Administrative Action Group Housing Development

Case File / Name: GH-3-09 / Beachwood Apartments - Phase 2

Nature of Case: A 40 unit group housing development consisting of two three-story multi-family structures on a 4.23 acre site zoned Neighborhood Business Conditional Use District with SHOD-4. The overall residential density is 9.75 units per acre after right of way dedication.

GH-3-09 / Beachwood Apartments – Phase 2 – Preliminary Development Plan

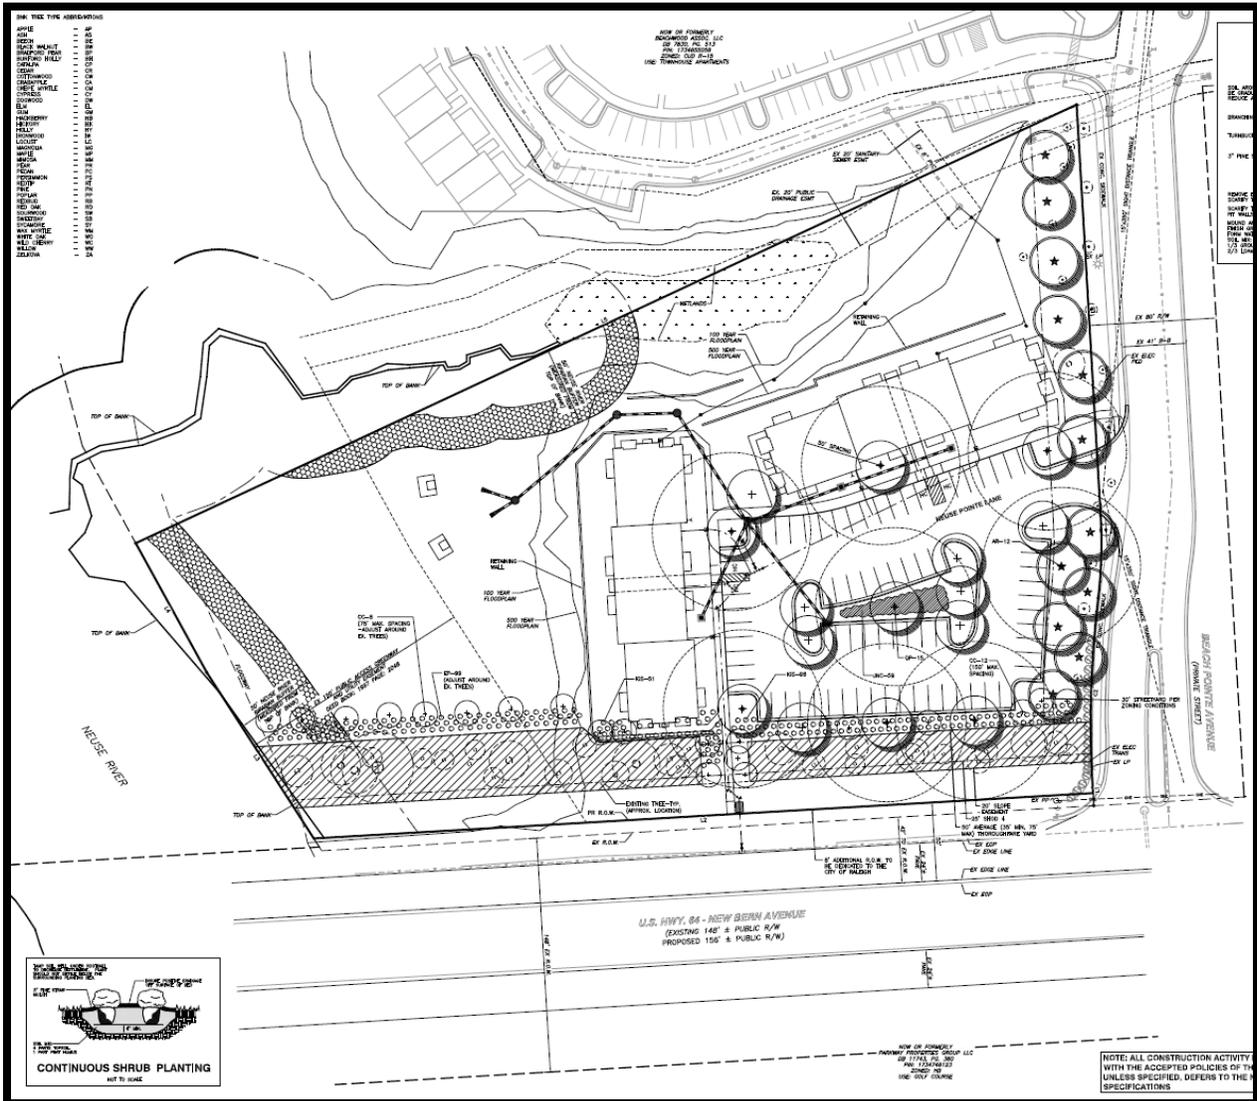
- A. General note #1: Specify CU material for water services. Also, domestic BFPs on individual services are not required with this configuration
- B. General note #2: Note indicates fire services are 4" DIP, but plan indicates 2" CU - please correct as appropriate. Note also indicates fire BFPs are located in yard, but they are not shown on plan. Either draft on plan or edit note to indicate they are located inside buildings. DCVA model may be selected instead of RPZ for this application

- C. If fire services are 4" DIP, specify 6"x4" tee & 4"x4" tee. If fire services are 2" CU, specify double strap bronze saddle at each tap; add a PIV to each fire service

- D. Fire hydrant must be located 3.0' min from FOC. If this conflicts with storm please extend further into yard; assembly installation label should include fire hydrant

- E. Cut profile on private water main to include storm crossing
- F. BFP located at ROW can be DCVA model instead of RPZ for this application
- G. Specify PVC or DIP material on 6" sewer services

- H. MB 1997 PG 2048 does not appear to dedicate 20' public sanitary sewer easements. Provide evidence that the downstream sewer has been certified by engineer & accepted by COR. Offsite sewer easements must be acquired prior to CD approval

- I. Under water & sewer sections of Utility Notes: edit 10' horizontal OR 18" vertical separation, not AND. Also note that DIP shall be installed to waterline specifications for 10' min each side of crossing

- J. Under general section of Utility Notes: edit "..... Notify engineer of any discrepancy. All necessary field revisions are subject to review & approval by the COR PUD prior to construction"
